Access Compliance Report

Public Rights-of-Way

(Curb Ramps)

Intersection ID: 29991	Main Street: BACKWATER_DR	Cross Street: NELAND_LN	Location:	E
ADA ID: 3C5F60AD1C0B	Ramp Type: Perp	Initial Pass/Fail: Fail	Overall Compliance: No	Severity Score: 25

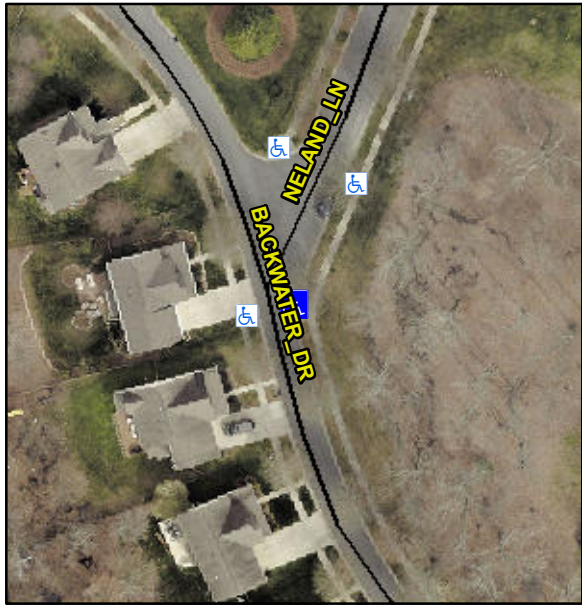
Codes/Mitigation Info/Possible Solution			Field Measurements/Component Compliance					
	Possible Solutions:		Compliance	Description	Data	Compliance	Description	Data
	Remove & Replace Entire Ramp.		N/A	Ramp Length (in)	73.0	Yes	Ramp Slope (%)	5.0
			Yes	Ramp Width (in)	48.0	No	Ramp XSlope (%)	7.3
			N/A	Flare Type LT	N/A	N/A	Flare Type RT	N/A
			N/A	Flare Slope LT (%)	N/A	N/A	Flare Slope RT (%)	N/A
			N/A	Flare Traversable LT?	N/A	N/A	Flare Traversable RT?	N/A
			N/A	Landing Length (in)	N/A	N/A	DWS Provided?	N/A
			N/A	Landing Width (in)	N/A	N/A	DWS Contrast?	N/A
			N/A	Landing Slope (%)	N/A	N/A	DWS Length (in)	N/A
			N/A	Landing X Slope (%)	N/A	N/A	DWS Full Width?	N/A
Surveyor Notes:			N/A	Landing Curb? (Y/N)	N/A	N/A	DWS Offset (in)	N/A
N/A			N/A	Shared Landing?	N/A			
PROW/ADA:			N/A	Gutter Ponding?	N/A	N/A	Gutter Slope (%)	N/A
Not Found, R304.5.3			N/A	Gutter Lip Ht (in)	N/A	N/A	Gutter X Slope (%)	N/A
